Addendum # 3 Coastal Resiliency and Living Shoreline Project

Date of Addendum: 9/13/22

NOTICE TO ALL BIDDERS AND PLANHOLDERS

RECORD DRAWING

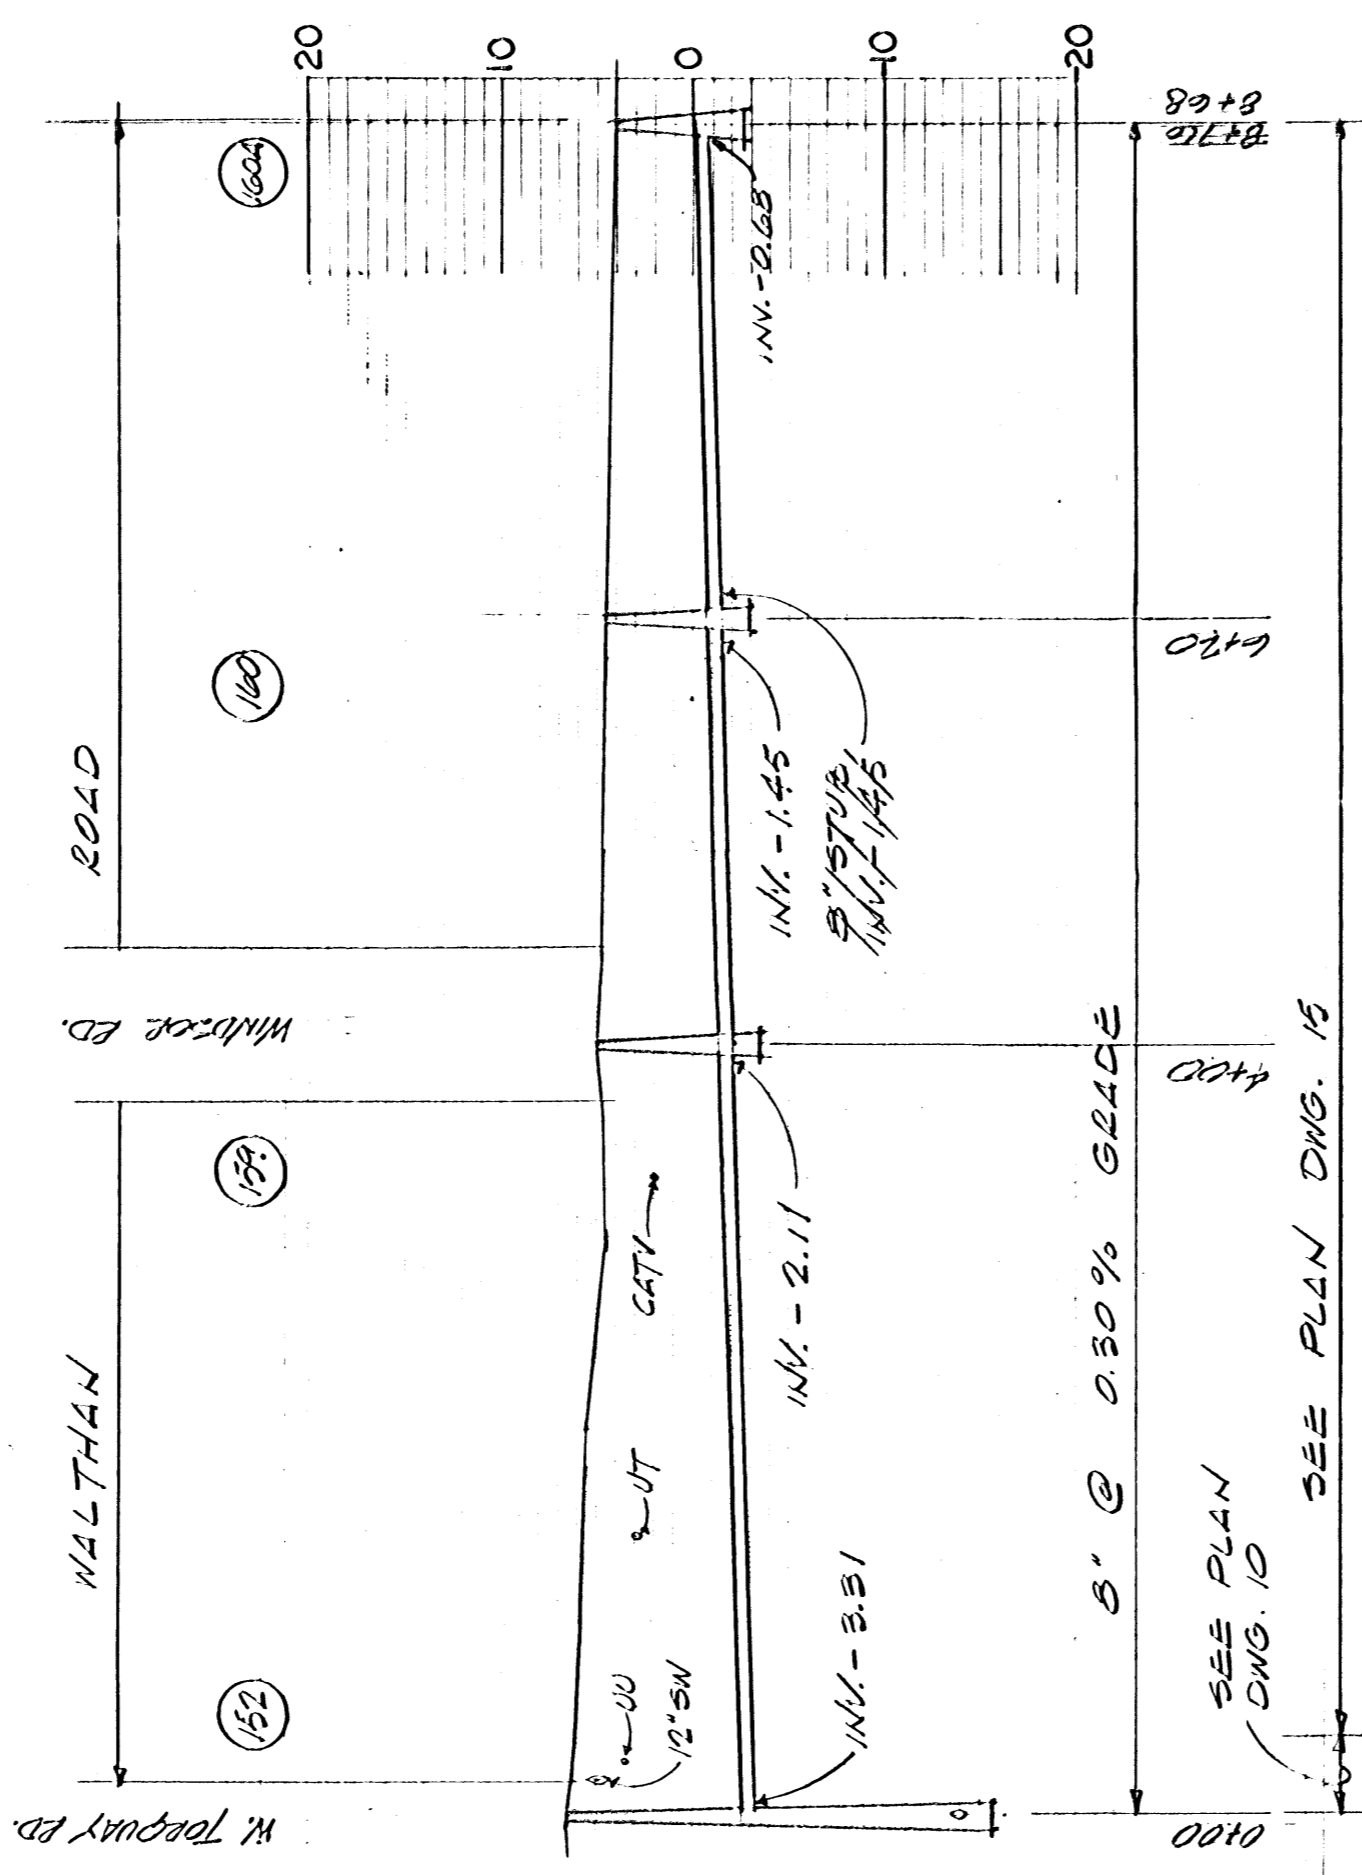
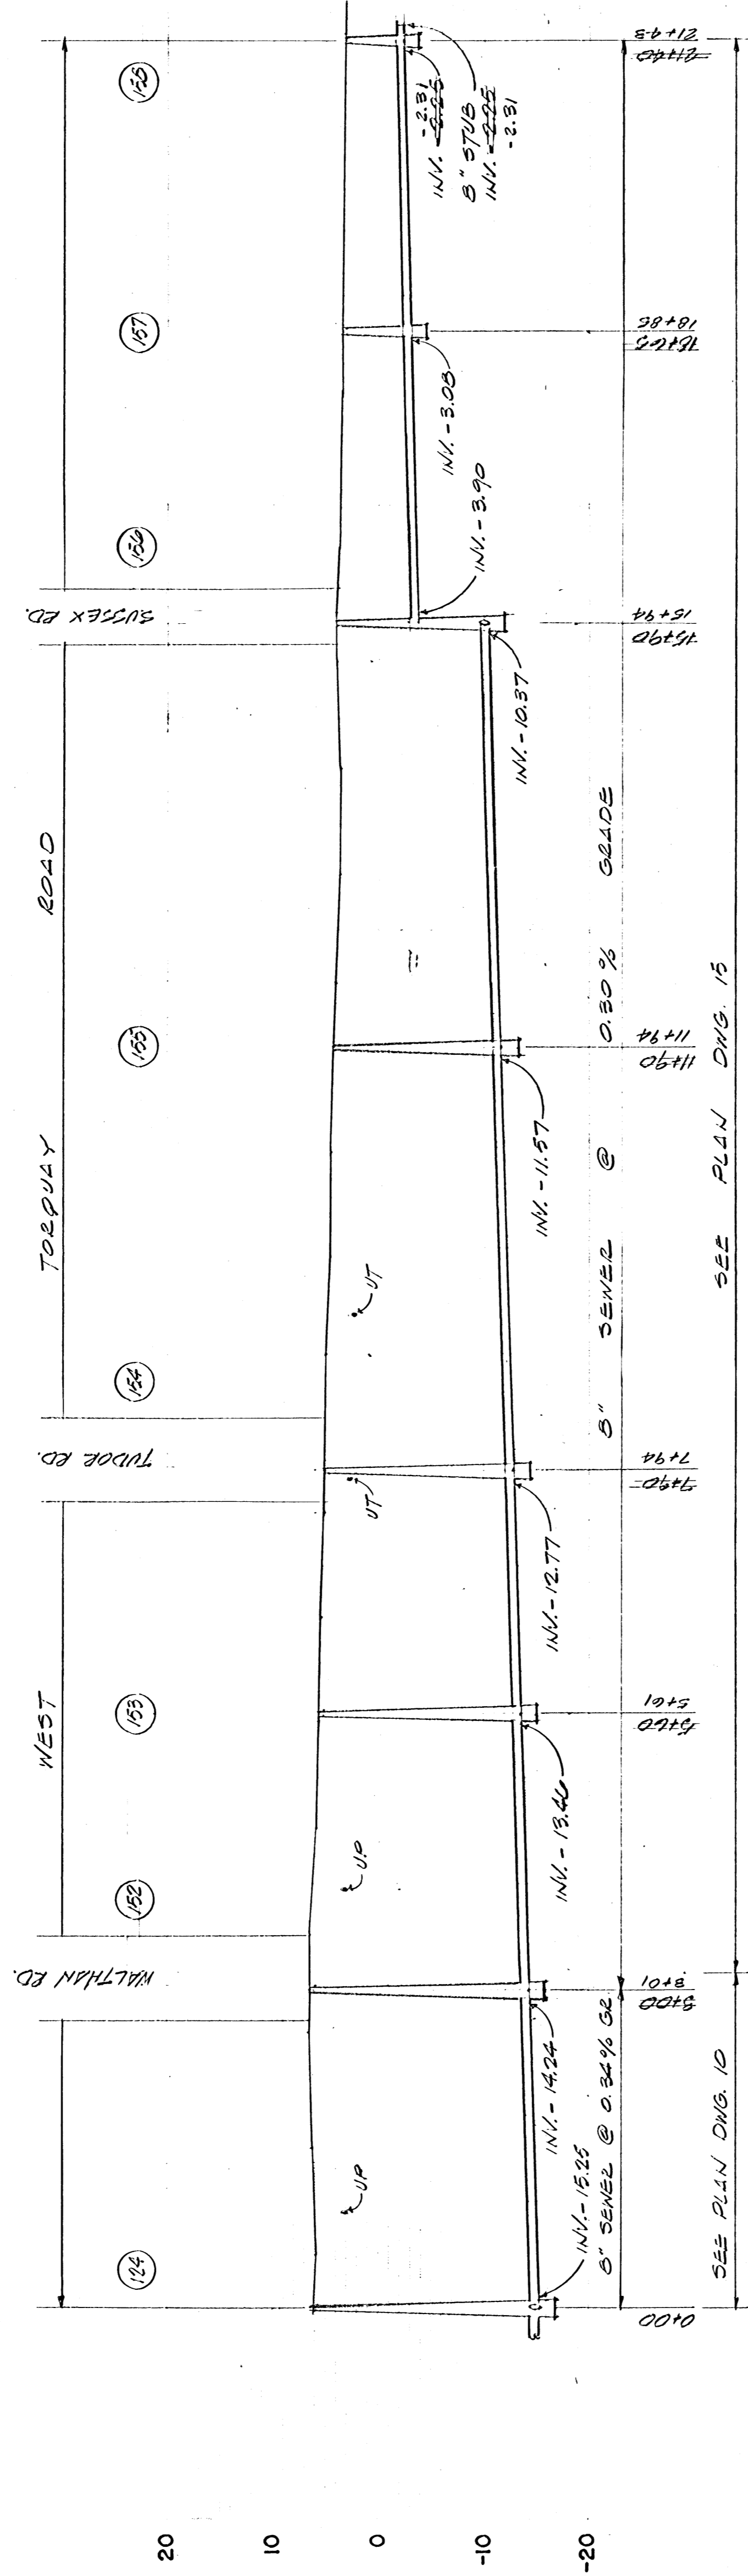
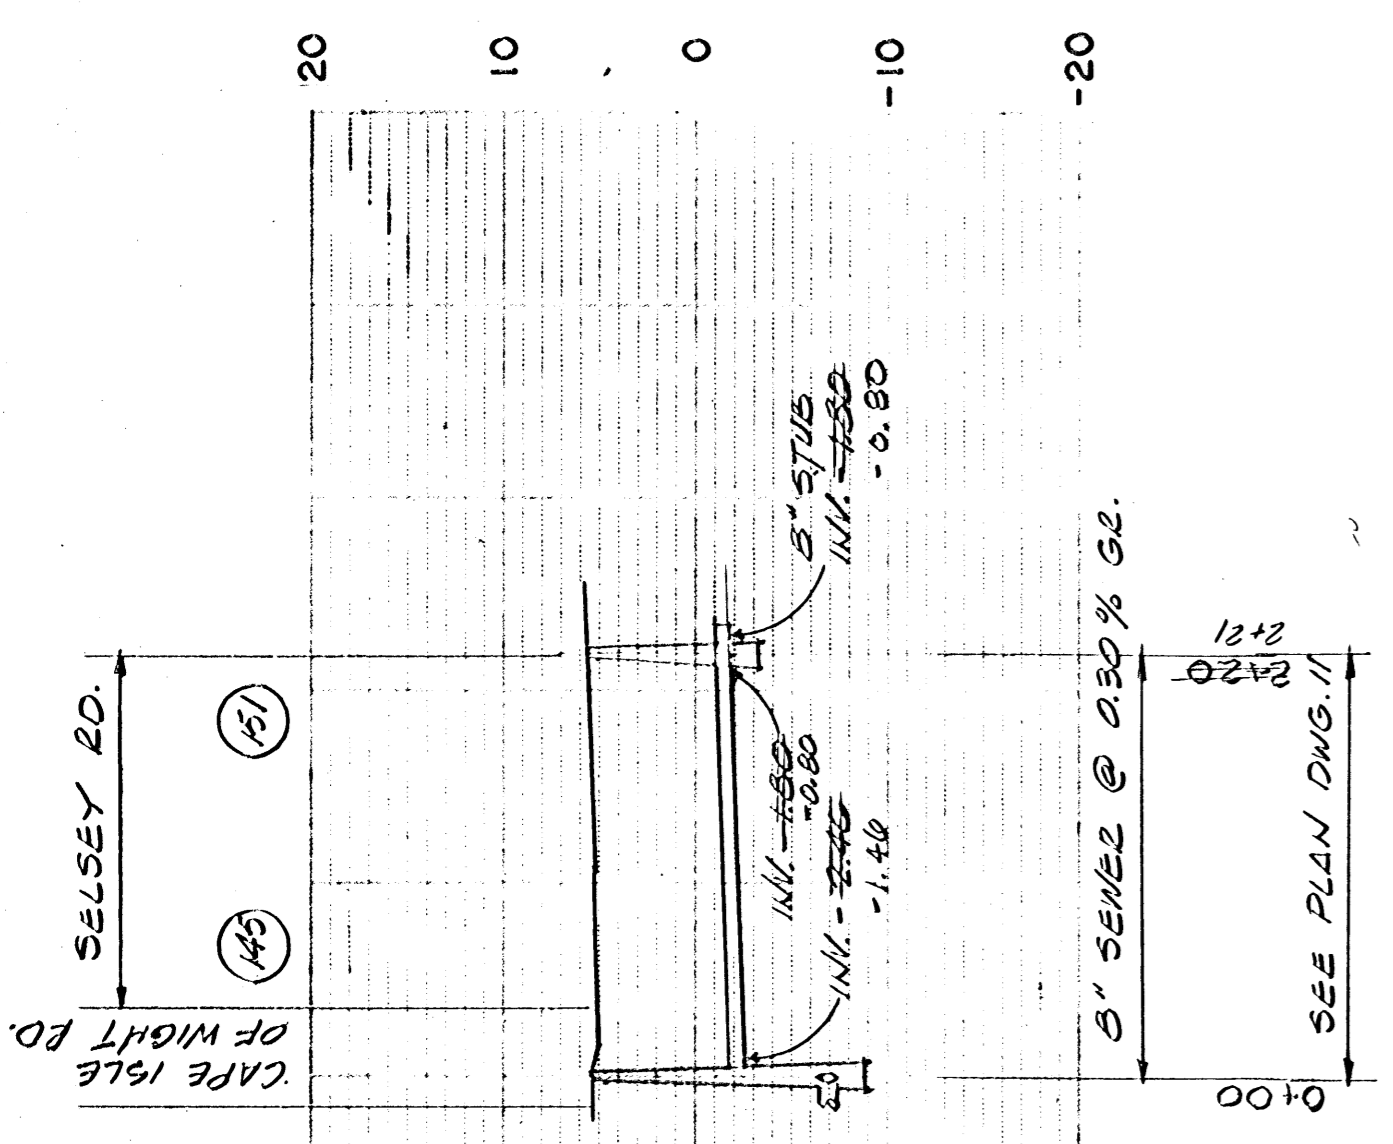
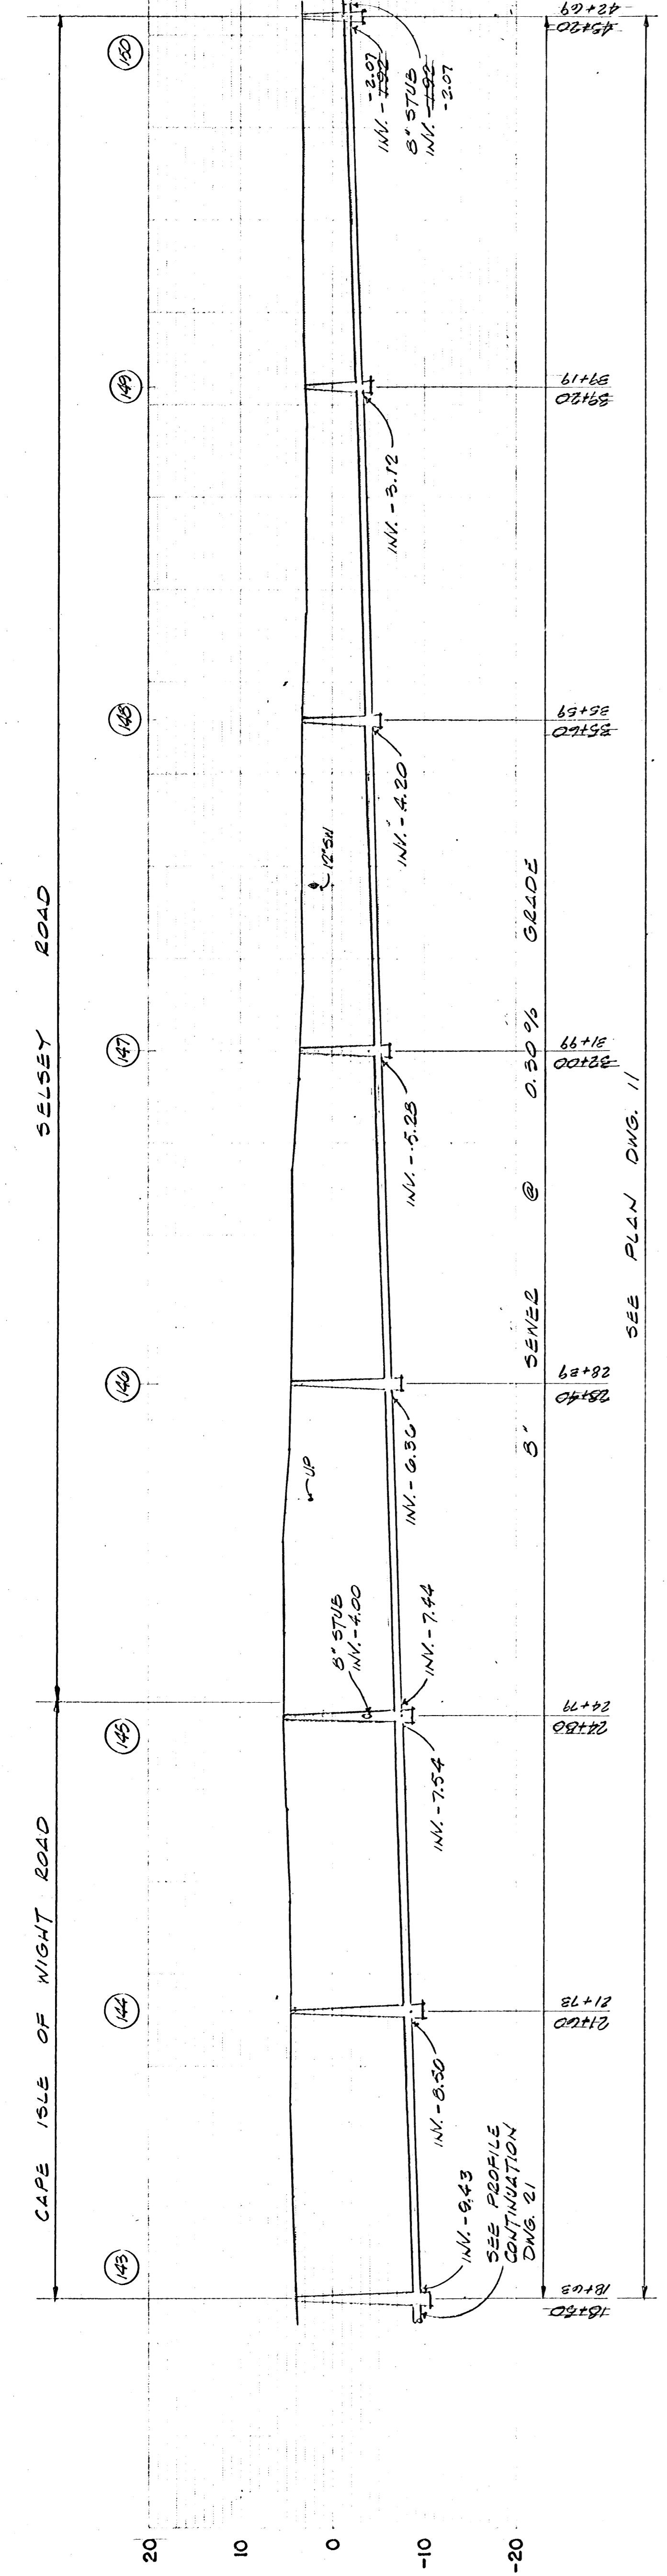
1.20	Q. Is there a survey of the sewer lines under the road? <i>A. Please see attached plans that illustrate location and profiles of sewer main.</i>
1.21	Q. Concerned about storm damage to the project ("act of God") and the responsibility of the contractor to repair damage during construction.

2.0 – ATTACHMENTS	
Item	Description
2.1	REVISED Construction Bid Form *This is to be used in lieu of the Construction Bid Form that was provided in the original Bid Documents.
2.2	Two files have been attached that illustrate location and profiles of sewer main.
